# Quiet Zone Implementation Study

**CITY OF MENLO PARK AND CITY OF PALO ALTO QUIET ZONE STUDY**

**Grade Crossing Improvement Diagnostic Meeting for  
Encinal Av Crossing (DOT 754988Y) in Menlo Park, CA  
Tuesday, December 13, 2022**

DOT# 754990A  
 OAK GROVE AV XING  
 CONCEPTUAL DESIGN LAYOUT

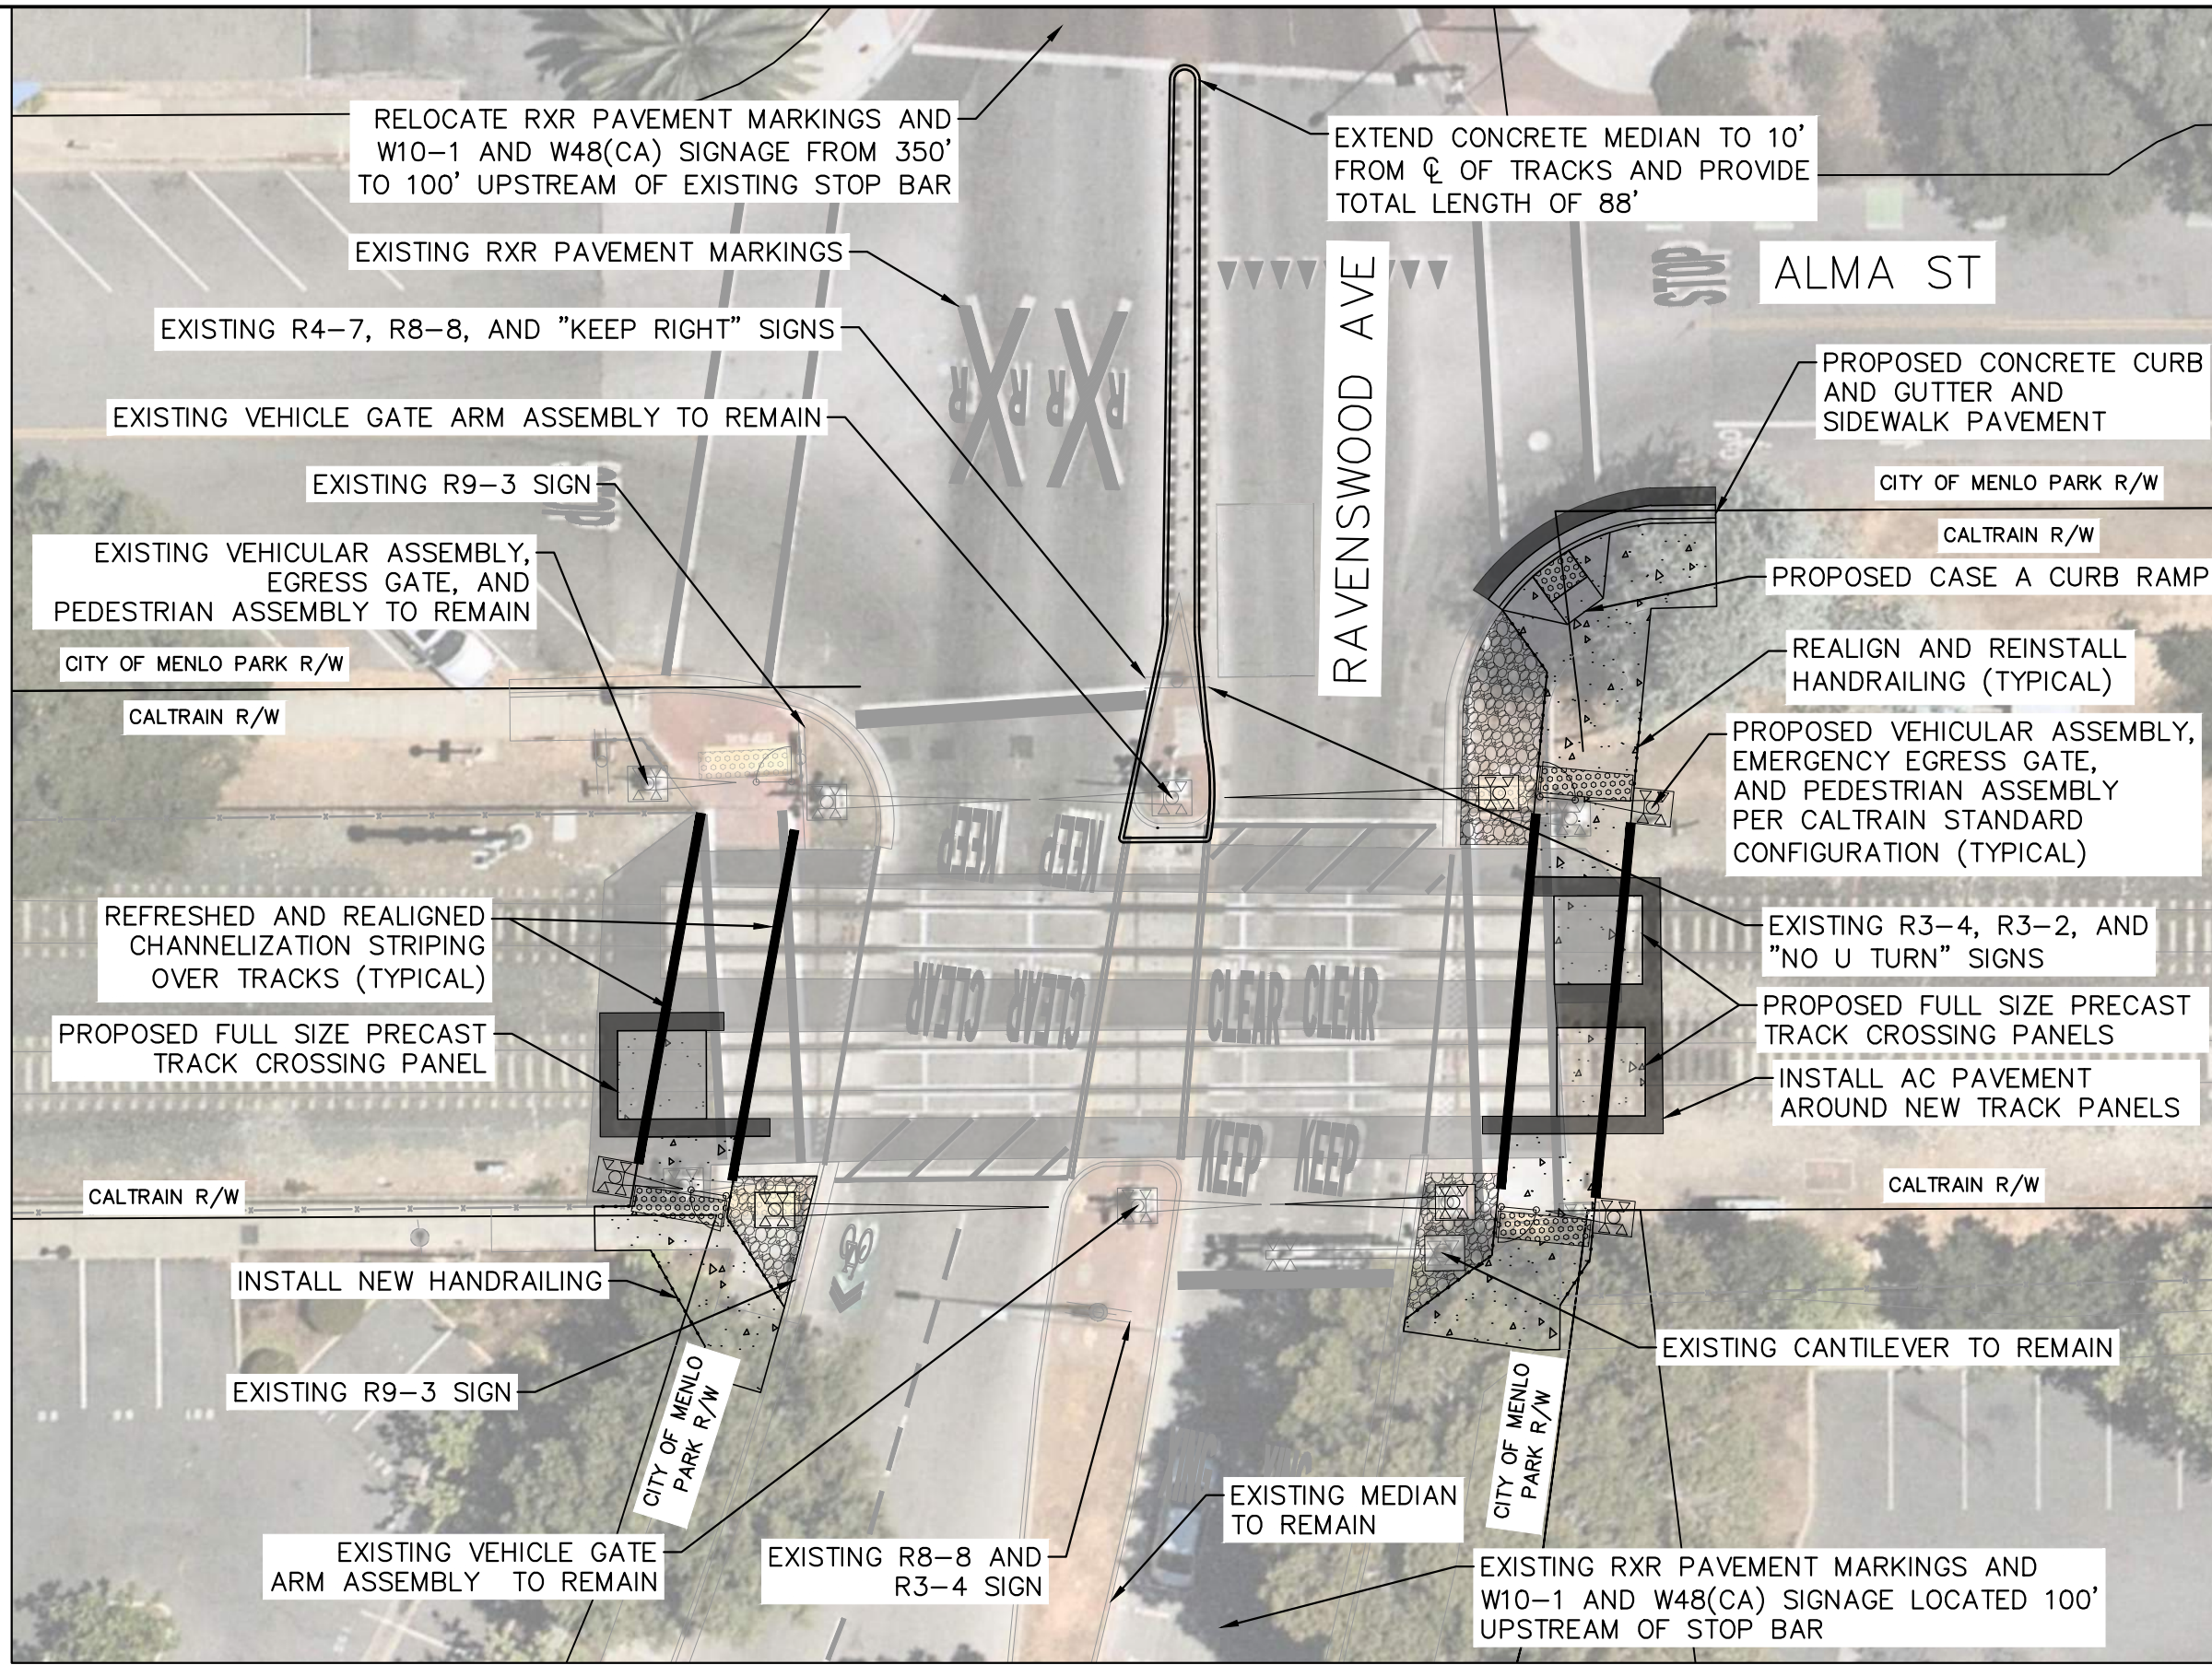
- **Roadway Existing and Proposed Conditions**
  - Existing ADT is 9,211 vehicles, 205 pedestrians, and 340 bicycles.
  - Proposed improvements show improvements to all 4 quadrants, to include exit gates, separated vehicle and sidewalk gate assemblies, additional track crossing panels, and sidewalk reconfiguration. Other improvements include relocation of signage and striping, as well as signage upgrades for regulatory compliance.
- **Train Operations**
  - According to FRA data, there are 104 thru trains and 4 switching trains per day.
- **Signal Operations**
  - Diagnostic team discussed potential interconnection of the crossing with El Camino Real, roughly 480' from the crossing.
  - CPUC noted during pre-diagnostic meeting that the crosswalk across Oak Grove (at Garwood/Merrill) may be a queueing concern. With a new development recently

completed/ in the final stages toward completion, pedestrian volumes are expected to increase. CPUC suggested signaling the intersection of Oak Grove Av and Merrill St/Garwood Way and adding advance preemption may be needed if the crosswalk creates additional queuing onto the tracks. The traffic signal would allow the left-turn movement from Oak Grove onto Merrill to be retained (no median necessary), while enhancing the safety. City would prefer to restrict left turns, especially in the short term as a signal is a major infrastructure project that could take multiple years to plan, design and fund.

- Diagnostic team noted proposed design does not conform to the existing sidewalk close to the curb line. Conceptual layouts to be revised to more accurately reflect the existing landscaping strip between sidewalk and roadway to show how the sidewalk would tie into existing conditions.

- CPUC and Caltrain noted that there was no longer a need for the guardrail surrounding the pedestrian assembly. Caltrain agreed to remove guardrail. The proposed improvements involve pushing the sidewalk N and installing an exit gate, so this entire sidewalk gate assembly would need to be relocated.

No signage or striping to indicate a crossing upon left turns from Alma St onto Oak Grove Av. Diagnostic team may consider installing a W10-4 as an added safety measure.

- Caltrain stated they are able to remove the cantilevered flashers on the combined vehicular/sidewalk gate assembly and the “no left turn” blank out sign.

- Improvements would encroach into the landscaped area of the new development.
  - City of Menlo Park indicated this development is supportive of the Quiet Zone and would likely be amenable to the R/W acquisition, if necessary, though this area may already be in the public right of way
- Diagnostic team noted the service pedestal for the “No left turn” blank-out sign and rail signals would need to be relocated.
  - Caltrain agreed to remove the blank out sign, so the service pedestal would likely be changed to only accommodate the rail signals.

- Kimley-Horn will draft Diagnostic Notes and provide to the Diagnostic Team for review/concurrence.
- Kimley-Horn will update the concept design to reflect the NW quadrant sidewalk more accurately, as well as “no train horn” signage for pedestrians.
- City will conduct a queueing study at the crosswalk S of the tracks, after the development in the SW quadrant reaches greater occupancy rates.
- City intends to install a temporary median extending through the intersection with Garwood Way/Merrill Street in the short term to address immediate queueing issues from left turning vehicles.

DRAWN BY: _____ DESIGNED BY: _____ CHECKED BY: _____ APPROVED BY: _____	JOB NO. _____ DATE: DECEMBER 2022 SCALE: _____ SHEET # _____ OF _____ SHEETS SHEET NO. _____
		MENLO PARK QUIET ZONE STUDY DOT# 754991G RAVENSWOOD AV XING CONCEPTUAL DESIGN LAYOUT

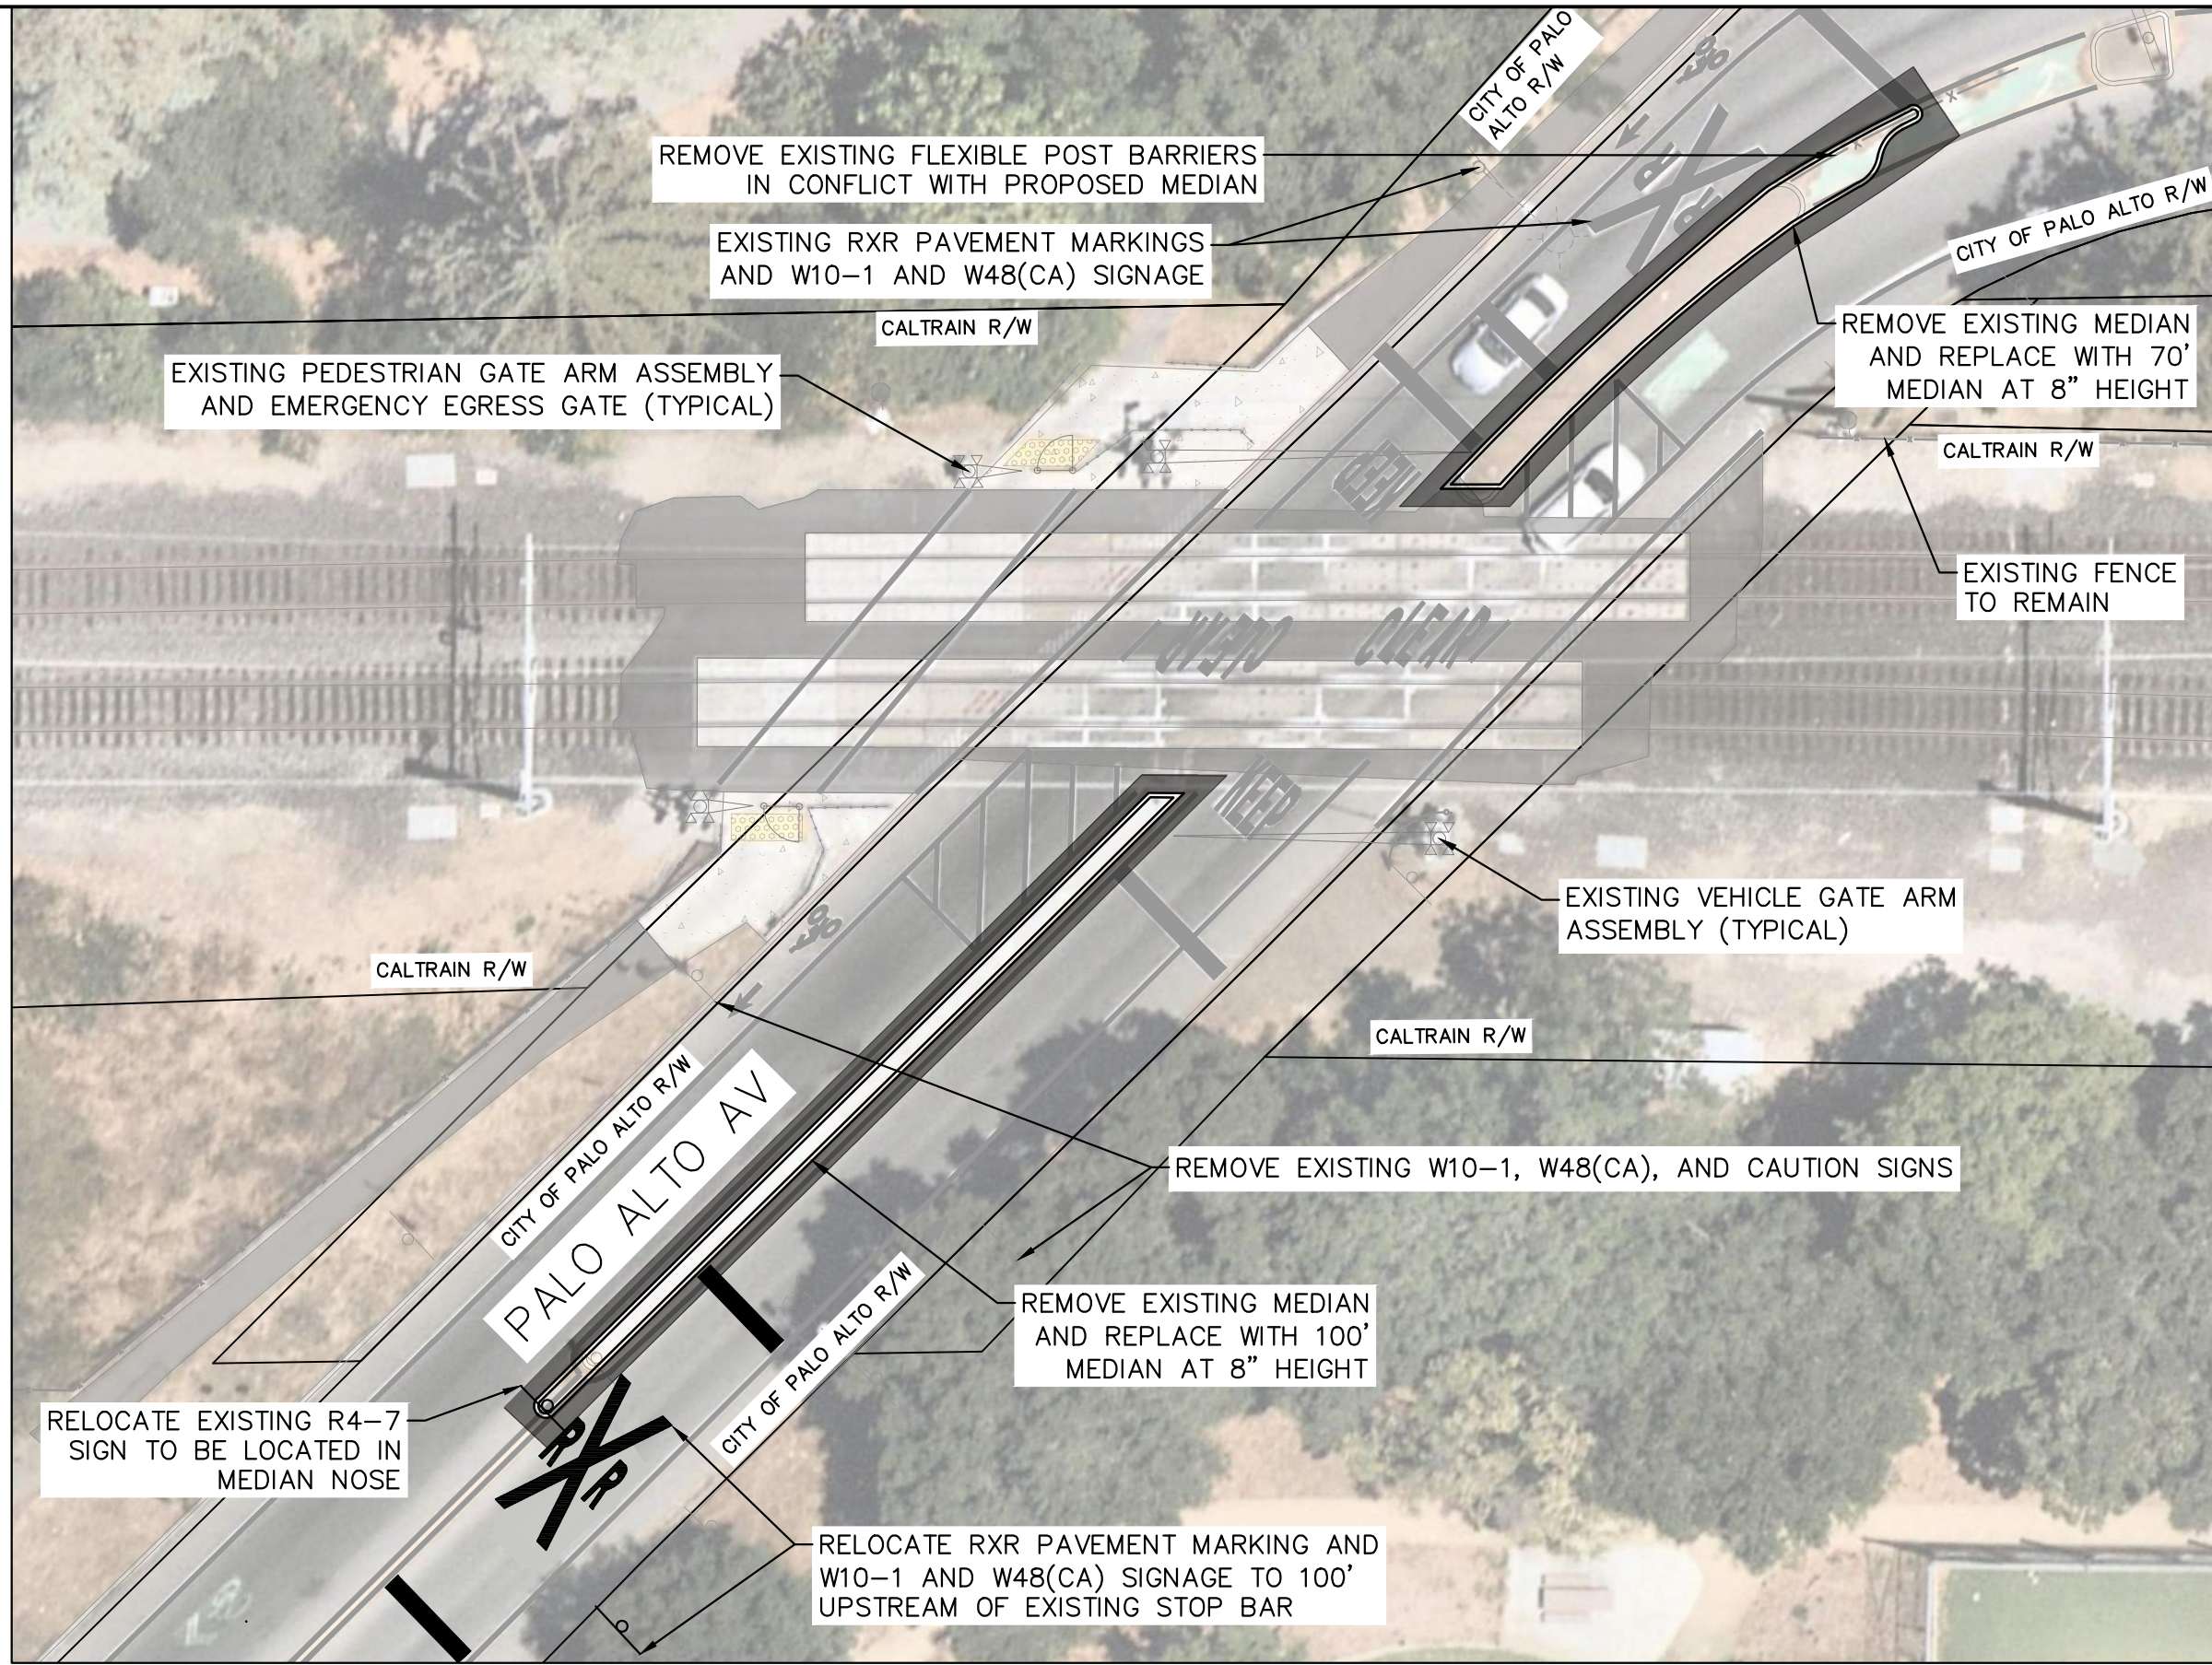
- **Roadway Existing and Proposed Conditions**
  - Existing ADT is 16,793 vehicles, 646 pedestrians, and 621 bicycles.
  - Proposed improvements show improvements to 3 of 4 quadrants, to include exit gates, separated vehicle and sidewalk gate assemblies, additional track crossing panels, and sidewalk reconfiguration. Other improvements include relocation of signage and striping, as well as signage upgrades for regulatory compliance.
- **Train Operations**
  - According to FRA data, there are 104 thru trains and 4 switching trains per day.
- **Signal Operations**
  - Diagnostic team discussed potential interconnection of the crossing with nearby El Camino Real.
  - Distance from crossing to intersection is on the edge for interconnection. Queueing had historically been an issue, likely due to the allowance of left turns onto and from Alma St

- Interconnection with El Camino Real would be in Caltrans domain, not the City's.

- Kimley-Horn will draft Diagnostic Notes and provide to the Diagnostic Team for review/concurrence.
- Kimley-Horn will update the concept design to include the two additional sidewalk gate assemblies being upgraded, as well as "no train horn" signage for pedestrians.
- Video for traffic counts will be revisited to determine if queueing due to crosswalk operations can be seen.

DOT# 754992N  
 PALO ALTO AV XING  
 CONCEPTUAL DESIGN LAYOUT

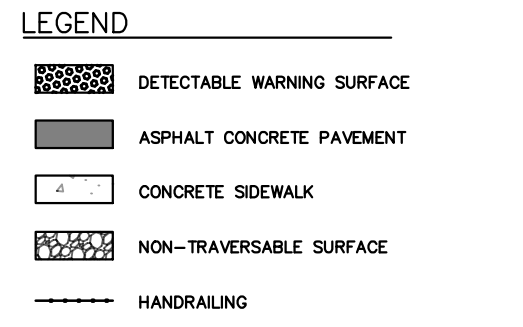
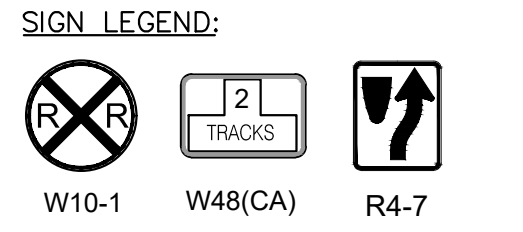
- **Roadway Existing and Proposed Conditions**
  - Existing ADT is 13479 vehicles, 389 pedestrians, and 670 bicycles.
  - Proposed improvements show removal and replacement of existing medians on both sides of tracks. Proposed medians are to have a minimum height of 8" to comply with FRA requirements, as well as increased total lengths to comply with FRA measures. Other improvements include relocation of signage and striping as well as signage upgrades for regulatory compliance.
- **Train Operations**
  - According to FRA data, there are 104 thru trains and 4 switching trains per day.
- **Signal Operations**
  - Diagnostic team discussed potential interconnection of the crossing with nearby El Camino Real.

- FRA noted no W10-4 signage along Palo Alto Av to warn drivers turning right toward the crossing. While there are pavement markings, a sign could be added.

- CPUC noted potential for sign clutter due to duplicate signs, with two R3-2 “except bikes” signs on the NB travel lane past the crossing.
  - Kimley-Horn will investigate potential regulatory reason for this sign installation and verify that potential need is due to site distance accommodation on the roadway curve.

- Kimley-Horn will draft Diagnostic Notes and provide to the Diagnostic Team for review/concurrence.
- Kimley-Horn will update the concept design to include “no train horn” signage for pedestrians where applicable, and evaluate the median extension/RIRO of Palo Alto Av on the east side of the crossing.
- Investigations ongoing to determine quiet zone qualifications for the Alma St crossing on its own (which would likely be managed by City of Palo Alto; personnel TBD).
